ADDENDUM NO. 2

POLYTECH SCHOOL DISTRICT
POLYTECH BUILDING RENOVATIONS
Bid Pack 'A' – Water Main Extension

This addendum is hereby made part of the Project Manual dated 28 October 2015 and Drawings dated 22 July 2015.

- I. Responses to Bidders' Questions
- II. Revisions to Project Manual
 - Section 004100 Bid Forms
 - Section 012300 Alternates
 - Section 011000 Summary of Work
- III. Revisions to Drawings
 - C301 Water Main Extension Plan & Profile
 - C302 Water Main Extension Plan & Profile
 - C303 Water Main Extension Plan & Profiles
 - C304 Water System Improvements

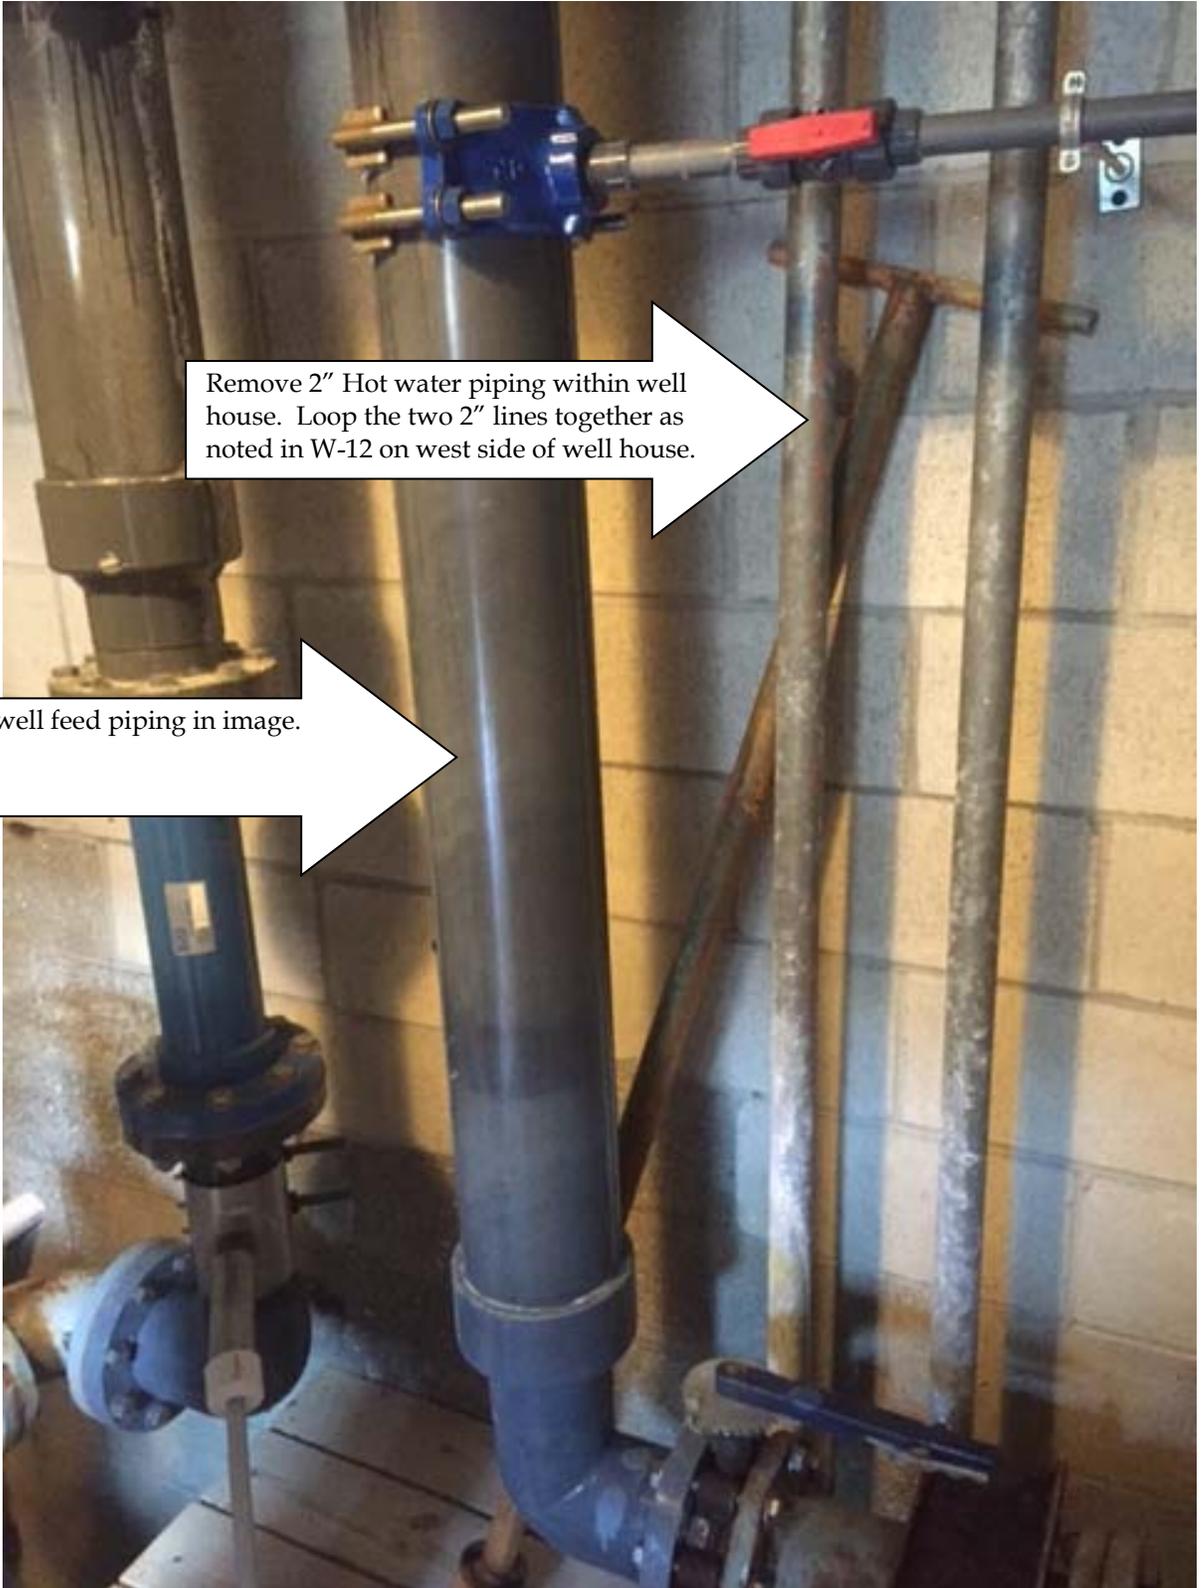
- 1) Sheet C-304 shows a mechanical sketch showing work to be completed in the well house. Can you provide a drawing showing exactly what gets removed/what gets painted? The sketch does not indicate exactly how this work is to be completed. See attached photos.
- 2) Is it possible to complete the work in the well house without disrupting service to the school? If not, how long can the school be out of service to complete the work?
- 3) Can the water tank water be emptied into the lawn catch basin?
- 4) Are there work hour restrictions?

1. Reference attached images and W notes from drawings:
2. The work in the pump house associated with tying in the 4" line will disrupt service to the school. This work will have to be done after hours, on a weekend, or on an in-service day.
3. The tank can be emptied in to the yard basin on the north side of the tower near the gym. The water must be pumped to the basin with a hose and not emptied directly onto the grass.
4. The normal hours of work are 7:00 AM to 3:30 PM Monday through Friday. If work needs to be performed outside of these hours they need to be coordinated with the owner and EDiS at least 7 days in advance.

W - 12
Remove downstream of 6" valve

Remove 2" Hot water piping within well house. Loop the two 2" lines together as noted in W-12 on west side of well house.
